**NUCLEAR REGULATORY COMMISSION**

Title: Advisory Committee on Reactor Safeguards  
Subcommittees on Reliability and  
Probabilistic Risk Assessment

Date: Thursday, January 23, 2003

## Staff Audit Calculations using RELAP5

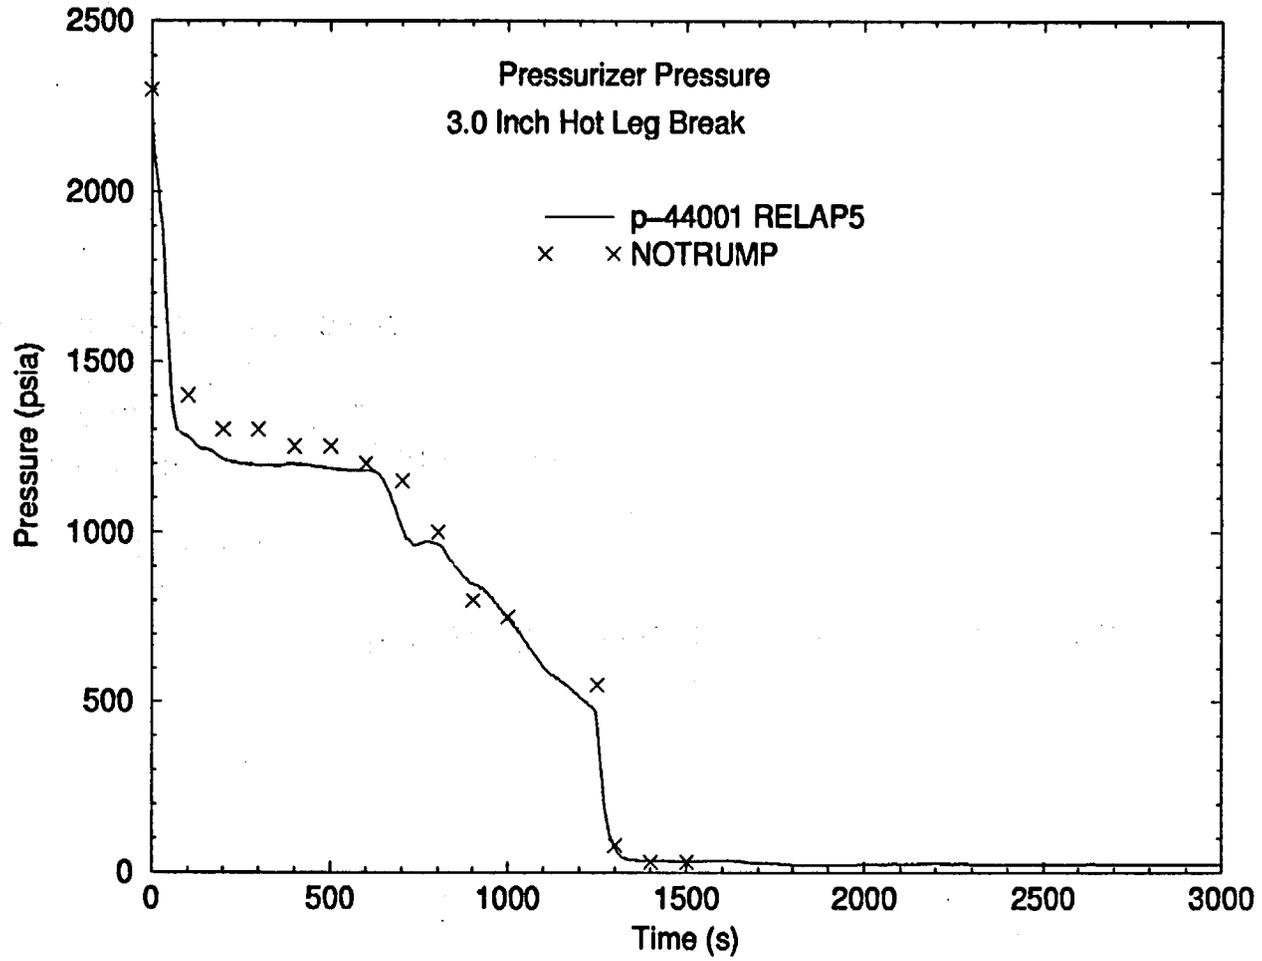
12 So basically the conclusions from the  
13 staff audit calculations are NOTRUMP and RELAP, you  
14 get about the same answer, and they show predicted for  
15 one case, and both codes predicted brief periods of  
16 core uncovering, which were within acceptable limits.

# RELAP MAAP Comparison

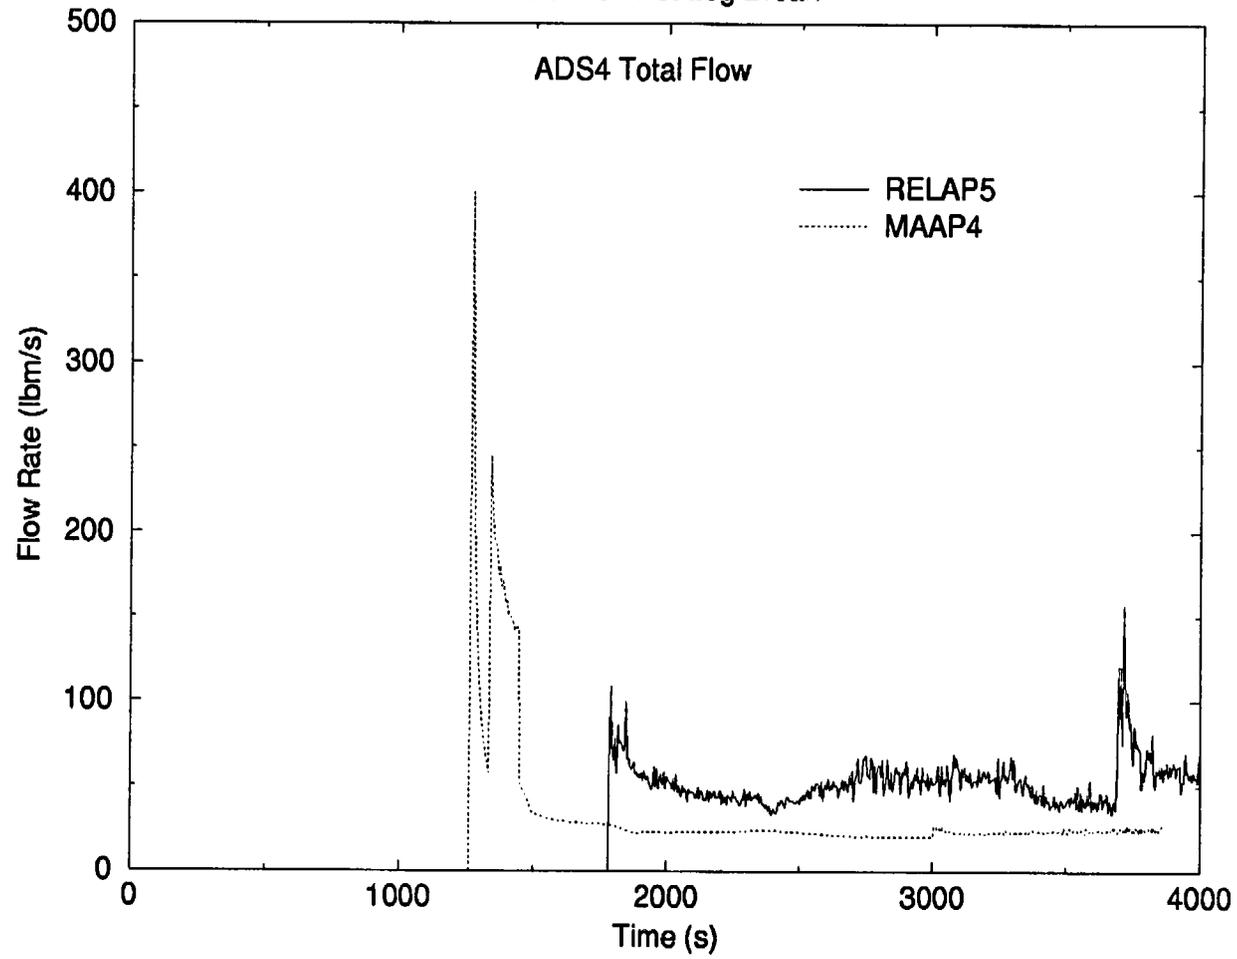
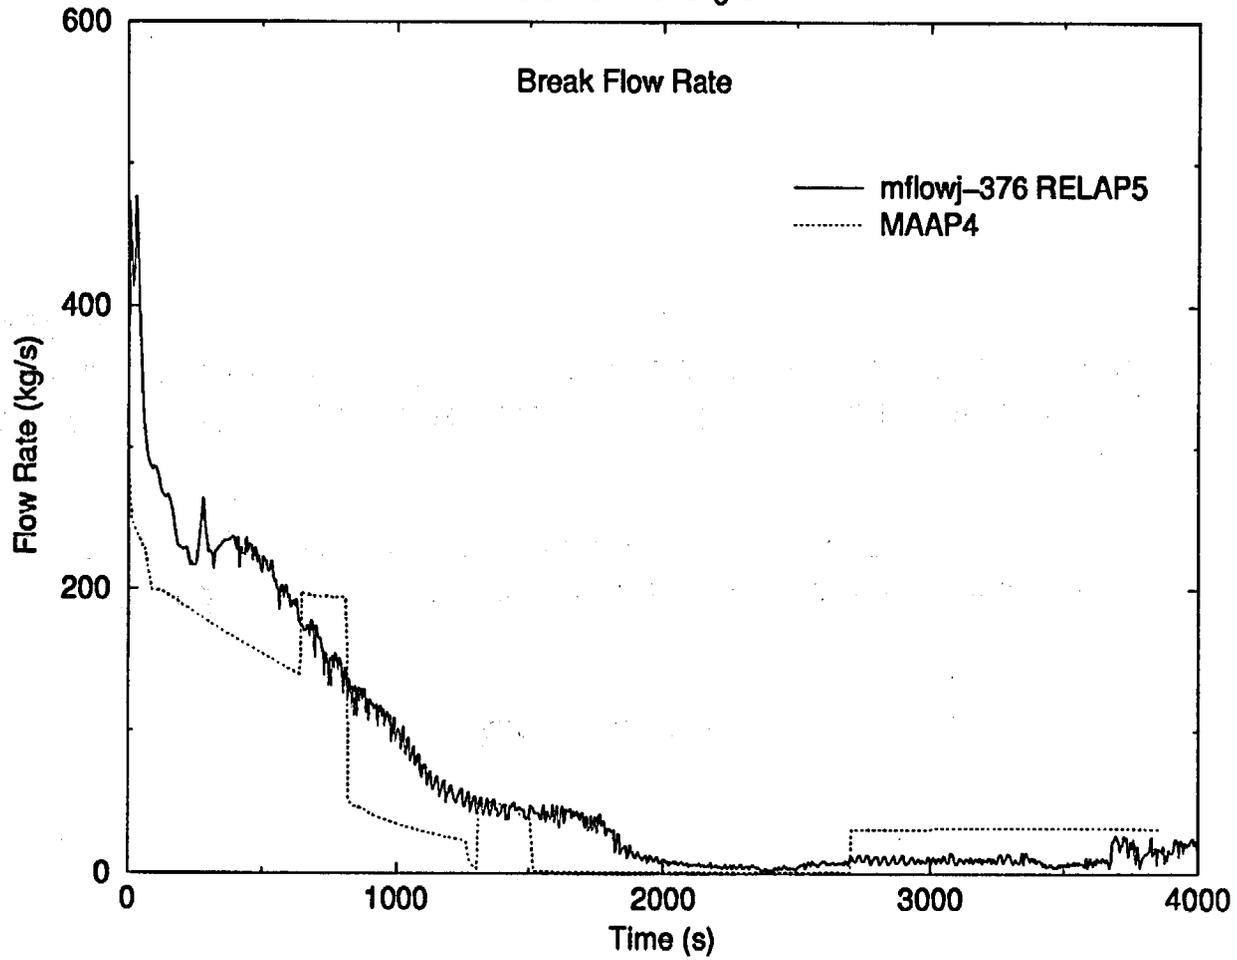
16 But an auxiliary question to that is have  
17 you looked at MAAP to see why it has this difference?

- NOTRUMP and RELAP5 show the same general trends of reactor system response for the two cases analyzed. Both codes predicted brief periods of core uncovering which were within acceptable limits.
- MAAP4 and RELAP5 predicted different trends of pressure, break flow and ADS4 flow. Although the results were different both codes predicted the core to remain covered and cooled for the case analyzed.

1 suspect that Westinghouse is keying the MAAP input to  
2 pretty much follow NOTRUMP as close as they can. So  
3 this is why we sort of get the same answer with RELAP.
